# Service Campaign Bulletin

Campaign No. 2007010001, February 2007

SUBJECT: **MODELS 164, 209, 211, 219, 251 AMG**  
**MODEL YEAR 2007**  
**REPLACE POLY V-BELT AND TENSIONER (M156 ENGINE)**

**Figure 1**

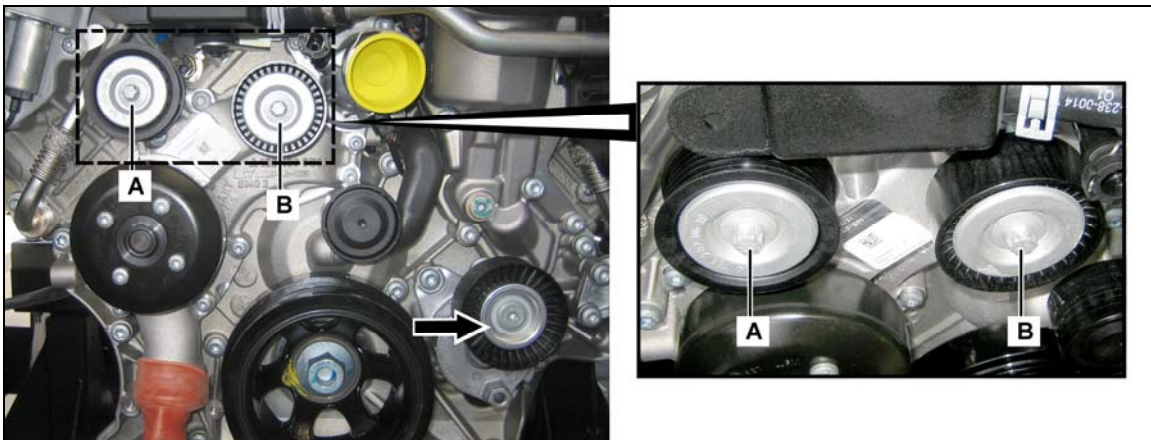
1. Open engine hood.
2. Remove poly-V-belt.
3. Replace poly-V-belt tensioner (arrow, Figure 1); refer to one of the following WIS documents, depending on vehicle model:
  - Model 164/251: AR13.25-P-3200GZS
  - Model 209/211/219: AR13.25-P-3200TMG

4. Check installation positions of guide pulleys A (grooved) and B (smooth).
  - If pulleys are not installed in positions shown in Figure 1, install pulleys in correct positions; torque bolts to 20 Nm.
  - If pulleys are installed as shown in Figure 1, proceed to next step.
5. Install new poly-V-belt.
6. Close engine hood.
